RE: Response to TCEQ NOD 3 Addendum – CCR105  
Luminant Generation Company LLC – Tatum, Rusk County  
Industrial Solid Waste Registration No. 31277  
EPA Identification No. TXD000821306  
Tracking No. 27220868; RN102583093/CN603256413

Table 1 - NOD Summary and Response  
Registration No. CCR105 - Luminant Generation Company LLC  
Application Deficiencies - Addendum to NOD 3

RE: Response to TCEQ NOD 3 Addendum – CCR Registration No. CCR105  
Martin Lake Steam Electric Station - Rusk and Panola Counties, Texas  
(SWR 31277; RN102583093; CN603256413; EPA ID No. TXD000821306)

**BEG Study Data Summary**

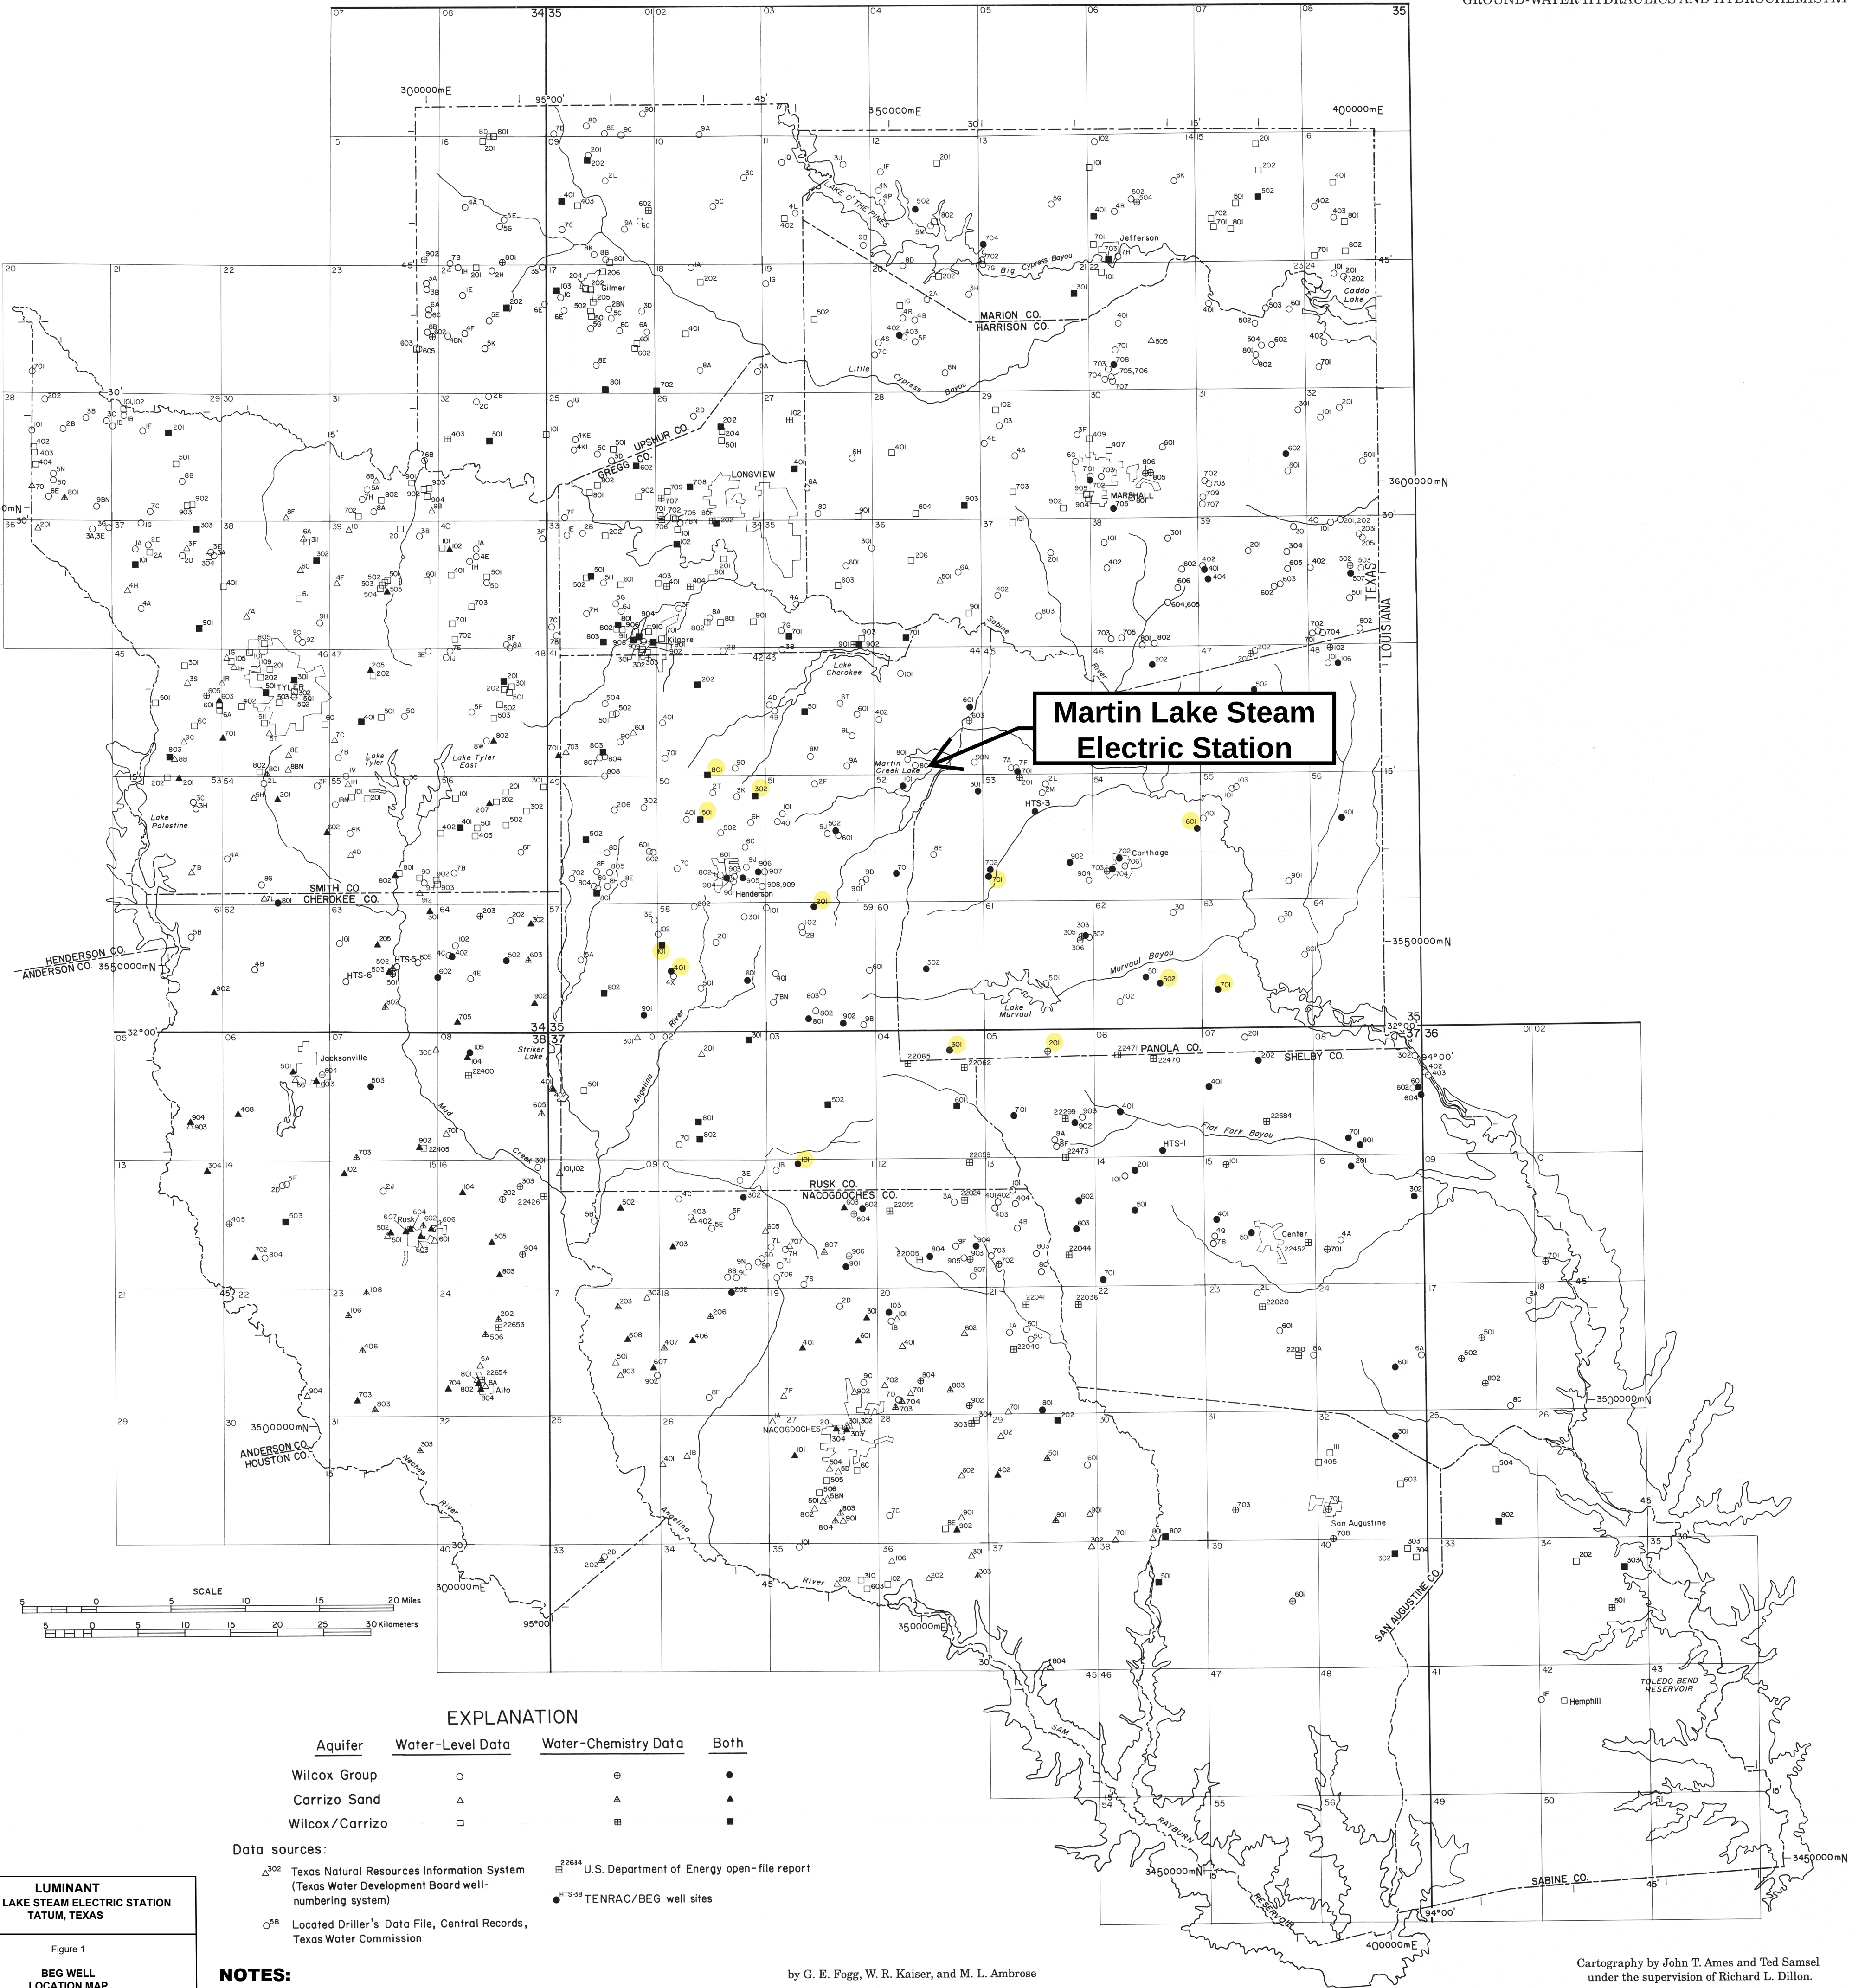
*Provide the location of the ASD-referenced sampled wells (distance and direction) in the Sabine uplift area in Texas, as cited in Texas Bureau of Economic Geology report (1991) as stated in the ASD submission.*

The groundwater sample data from the BEG study are reproduced in Attachment 6, Table 1. The well location map from the BEG study is reproduced on Attachment 6, Figure 1 with the approximate location of the Martin Lake Steam Electric Station added for reference. Groundwater sample data collected as part of the PDP-5 CCR program were presented in the 2024 Annual Groundwater Monitoring and Corrective Action Report (BBA, 2025b) and in other documents submitted to the TCEQ as part of the CCR unit registration.
